ERIE POLICE DEPARTMENT EXPANSION & REMODEL
EXTERIOR FINISHES

Subject: Erie Police Department Addition and Renovation (SP2025-00009)

To: Harry Brennan, Senior Planner
From: Merritt Taylor, Development Engineer
Date: September 11, 2025
Re: Erie Police Station Expansion - Review 2

To: Harry Brennan, Senior Planner
From: Merritt Taylor, Development Engineer
Cc: Chad Schroeder, Development Engineering Manager
Date: July 3, 2025
Re: SP2025-00009 Erie Police Department Expansion – Site Plan

SECURE PERIMETER FENCE

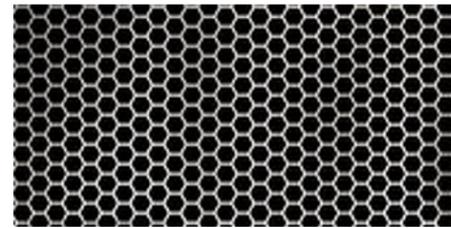
Note - This applies only to the fence on the west side of the property adjacent to the trail. We would be interested in looking into permeable "wrought iron" type fencing adjacent to trail. Also if 5' is inadequate for security purposes, we can also have a conversation with Planning & Development Director and folks in DNS in Parks & Rec about alternatives.

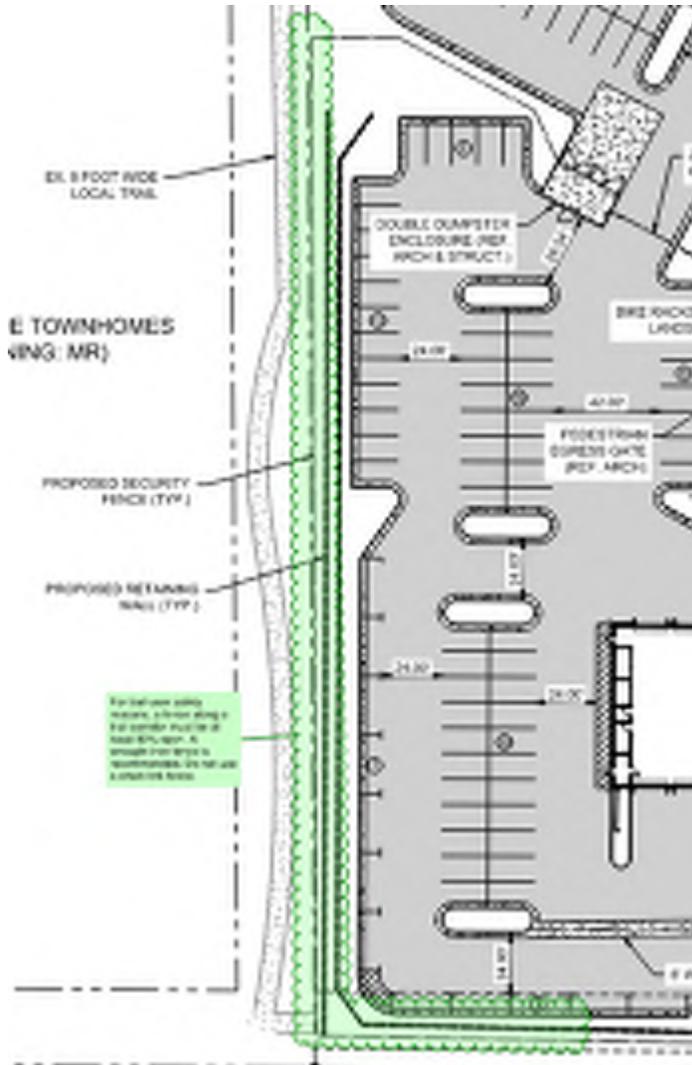
1. Solid fences are not allowed along a trail corridor as it creates a safety concern for trail users (see image below). Code section 10-6-4.F.4.b says:

Given the circumstances of required security for a police station, parks would be in support of a variance to allow a taller fence, however, due to safety for trail users, we would not be in support of a fully opaque fence. We recommend a black wrought iron fence. Chain link fences are unsightly, and we would not be in support of their use. For ease of maintenance, we prefer that the fence be placed on top of the retaining wall to avoid creating a strip of vegetation between the fence and top of retaining wall that is difficult to maintain.

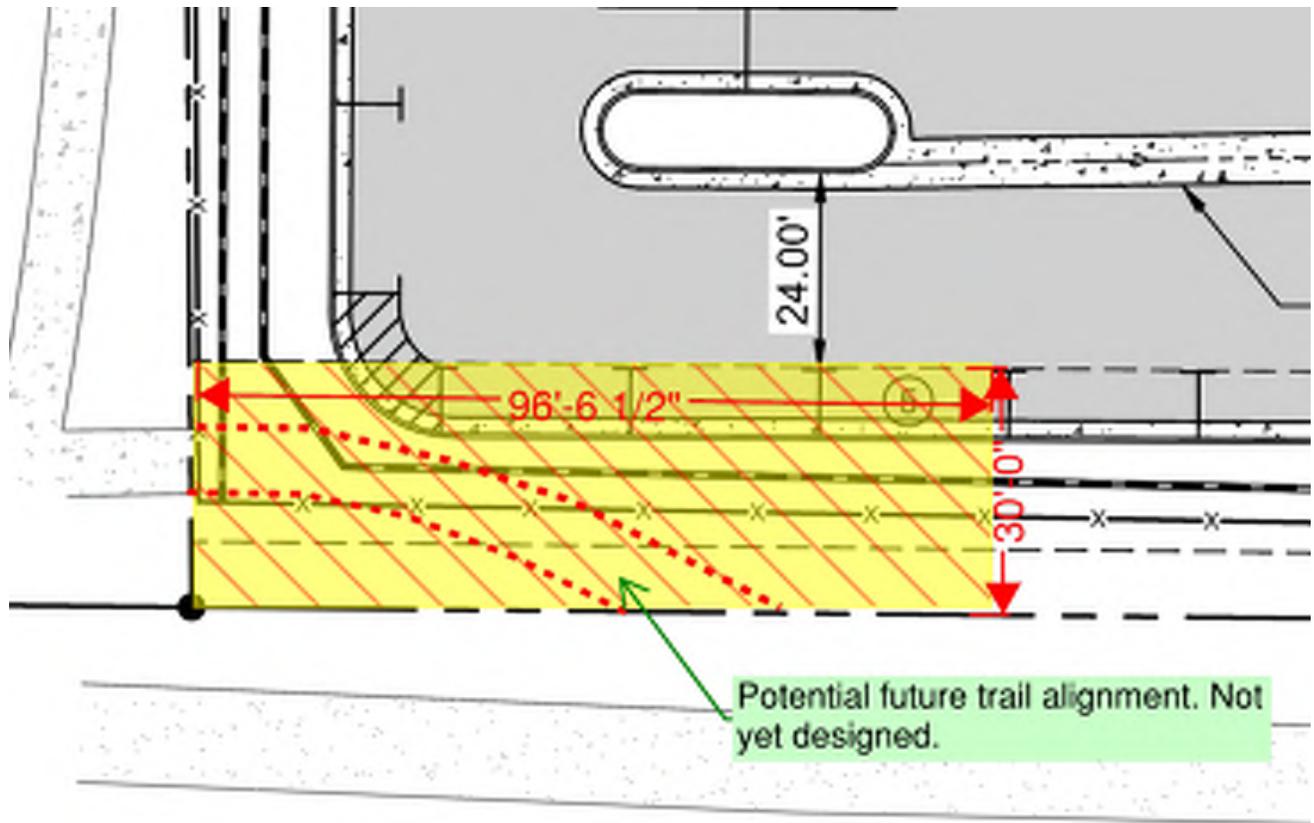
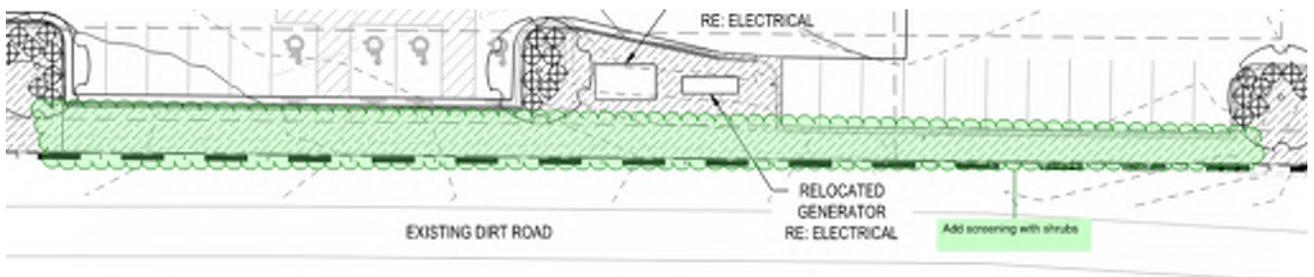
2. Provide an approximately 30' by 100' unfenced and unwallled area for a future trail connection between the existing spine trail to the west and a future trail continuation on the property to the south. See image below. The 30' x 100' dimensions can be adjusted slightly as needed for the drive aisle and parking, however, the area must be graded in a way that prevents grading issues upon construction. The area can be landscaped with native seed. Please provide irrigation to the area in a way that would accommodate the trail construction and future plantings. *The trail extension does not need to be built as part of this project.*

SECURE PERIMETER FENCE

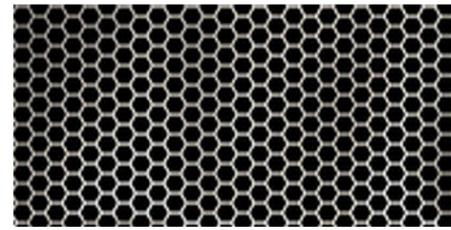
Thank you for the description - please add the details on the trash enclosure & gate design from the CD's (note - 9' fence height is not allowable by the UDC)
Also please add design detail for retaining wall when material is known
